ZONING AMENDMENT,
PLANNED UNIT DEVELOPMENT &
SUBDIVISION STAFF REPORT

Date: August 4, 2005

<u>NAME</u>	Millennium Mobile, LLC
<u>LOCATION</u>	11 Government Street (Southeast corner of Government Street and South Water Street extending to the Mobile River)
<u>CITY COUNCIL DISTRICT</u>	District 2
<u>PRESENT ZONING</u>	R-1, Single-Family Residential, I-1, Light Industry, and I-2, Heavy Industry
<u>PROPOSED ZONING</u>	B-4, General Business
<u>AREA OF PROPERTY</u>	4.6 acres \pm
<u>CONTEMPLATED USE</u>	<p>Subdivision, Planned Unit Development and Rezoning approval to permit residential condominiums and retail sales, with multiple buildings on a single building site and shared access between two lots.</p> <p>It should be noted, however, that any use permitted in the proposed district would be allowed at this location if the zoning is changed. Furthermore, the Planning Commission may consider zoning classifications other than that sought by the applicant for this property.</p>
<u>TIME SCHEDULE FOR DEVELOPMENT</u>	Immediate

SITE PLAN

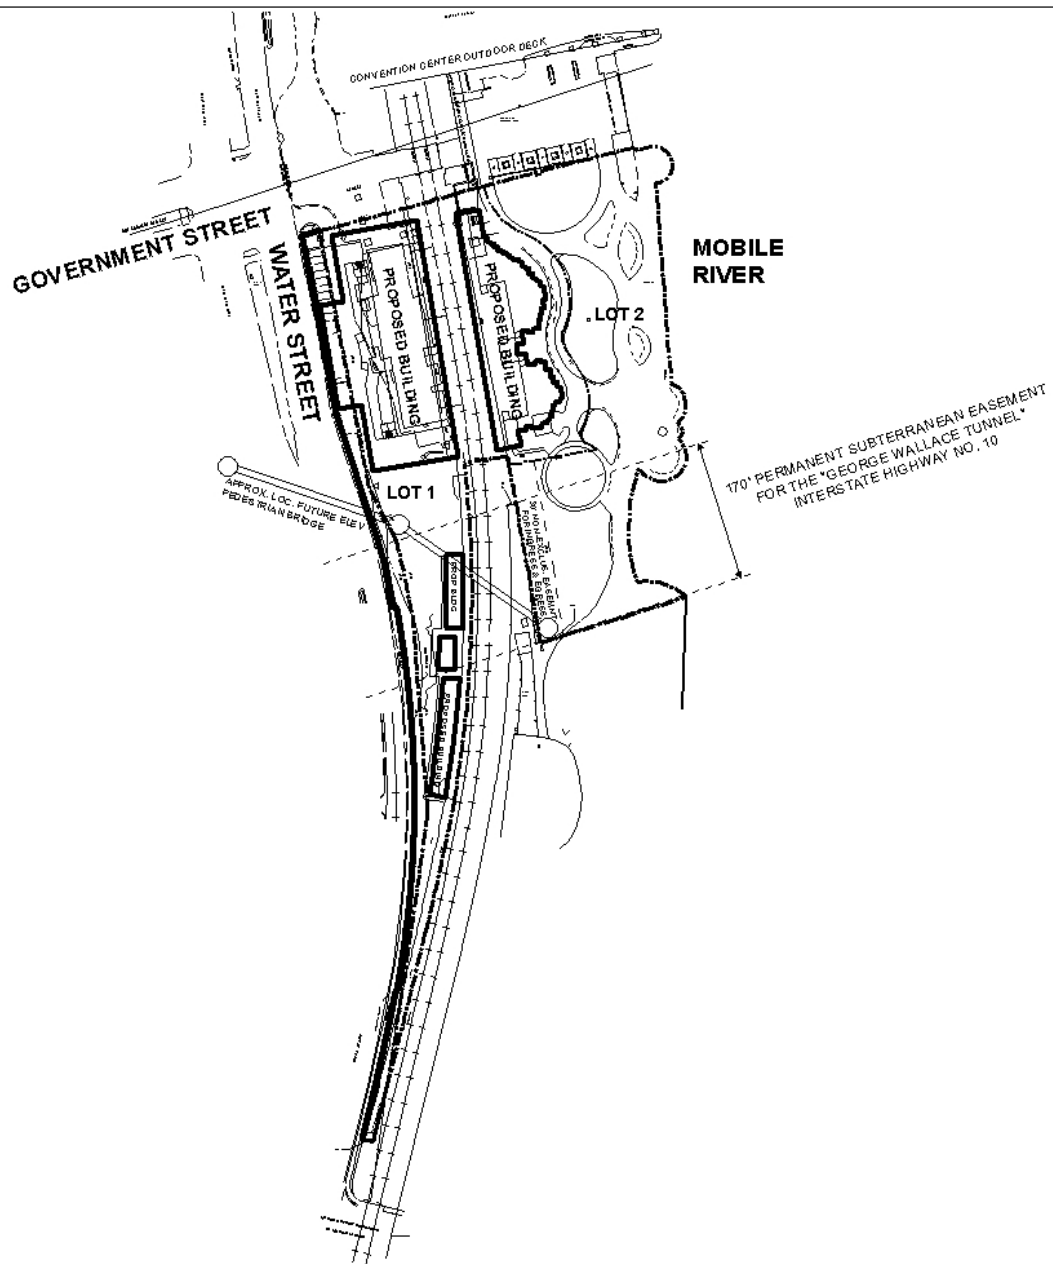
The proposed use is compatible with the location in the urban core, and specifically the adjacent convention center, museum, park and passenger maritime uses. However, there are several concerns regarding the proposed development. A majority of the site is located in the “Core Area” – an area in downtown Mobile that is exempt from the parking requirements of the Zoning Ordinance. As a vast majority of the development proposed for the site will be located within the parking exempt area, and as the remaining portion of the site is severely constrained by adjacent railroad tracks and road rights-of-way, an exemption from all parking requirements would be appropriate. It is anticipated, however, that parking on-site or off-site will be needed to satisfy residential and commercial market demands. Furthermore, proposed on-site vehicular and pedestrian circulation, including access to adjacent roads and pedestrian facilities, should be clearly delineated on the site plan.

A second concern is the proposed location of a portion of the proposed buildings within or over a portion of the right-of-way of Water Street. Specifically, a portion of the structure proposed for the western side of Lot 1 appears to project 15 feet into the right-of-way for Water Street, but is approximately 10 feet from the edge of pavement. Close proximity of structures to the edge of pavement is not uncommon in the downtown area, however, all structures and portions thereof must be located on private property. Therefore, either that portion of Water Street would have to be vacated or the building redesigned to be completely contained within the private property.

A third concern is the apparent lack of waste disposal and loading dock facilities indicated on the site plan. A mixed-use development of this nature will likely require dumpster and loading dock facilities, thus, such facilities should be indicated on the site plan.

A fourth concern is that the site plan provided for the PUD application does indicate the provision of a sidewalk along Water Street. Sidewalks are provided north at the convention center, and south of the CSX terminal, along Water Street. Providing a sidewalk to bridge the gap between the two locations would be appropriate, especially due to the pedestrian traffic that is currently being generated by the convention center, cruise terminal, the Exploreum, and the existing museums. Furthermore, the proposed development and the anticipated maritime museum will significantly increase the number of people in the area, thus the provision of a continuous sidewalk along this segment of Water Street is in the interest of the general public's health, safety and welfare.

Planned Unit Development: The PUD request is recommended for Preliminary Approval, subject to revision of the site plan and the following conditions: 1) depiction of on-site vehicular circulation; 2) vacation of the right-of-way, or redesign of the structure so as not to protrude into the right-of-way for Water Street; 3) depiction of dumpster and loading facilities on the site plan; 4) provision of a sidewalk, where lacking, along Water Street; 5) compliance with the tree and landscaping requirements of the Zoning Ordinance, to the greatest extent possible, in coordination with Urban Forestry; 6) full compliance with all other municipal codes and ordinances, and; 7) additional application/approval from the Planning Commission if substantial changes are made to the site plan.
